SAN DIEGO GAS & ELECTRIC SAN MARCOS TO ESCONDIDO TIE LINE (TL) 6975 69kV PROJECT

Final Initial Study/Mitigated Negative Declaration

January 2020

Figure 3.1-16
KOP XX Existing and Proposed Conditions
at Simmons Family Park Picnic Area – Looking Southwest

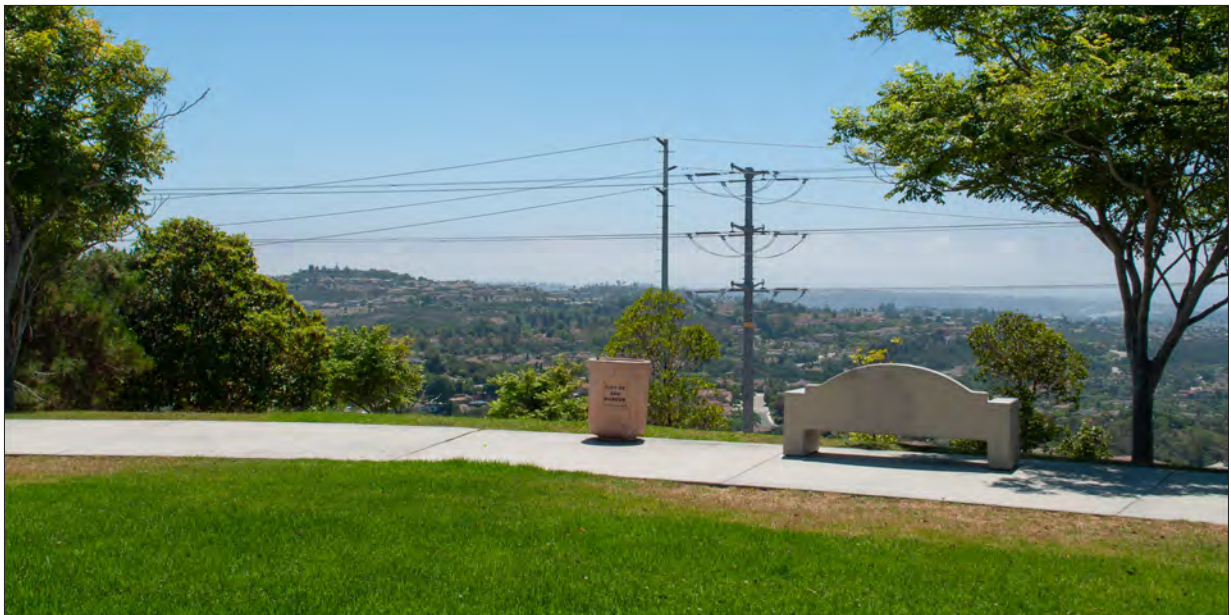
- I3-5 Master Response 1 responds to comments about views from Simmons Family Park. Two additional views have been evaluated through photos and a photo simulation to address this viewpoint (VP 5 in Final IS/MND Figure 3.1-10 and KOP XX in Final IS/MND Figure 3.1-16). The CPUC acknowledges the photo simulations presented in the commenter's pictures 30 and 32. For reasons described in Master Response 1 and in revisions to the analysis of cumulative aesthetic impacts in Chapter 3, the simulation of pre-2010 conditions shown in picture 30 is not relevant to the analysis of the aesthetic impacts attributable to the Project. The original photo (picture 31) and simulations presented are panoramic images with an unspecified vantage point, field of view, and methodology for creating the simulations. The original image appears to be taken from a drainage culvert located downhill from the playing field; no public trails are located in that area. Distortions are visible in the appearance of the existing and simulated proposed power lines bending upward in the center of the photo in pictures 31 and 32. The CPUC's analysis uses a photo simulation that was prepared using the same methodology used for the simulations presented in the Draft IS/MND, which presents a more realistic view from the accessible areas of Simmons Family Park from which the SDG&E ROW can be viewed.

The evaluation of the Project's effect to the visual character and quality of public views and surroundings at KOP XX is discussed under Question a and illustrated in Figure 3.1-16, *KOP XX Existing and Proposed Conditions at Simmons Family Park Picnic Area – Looking West*.
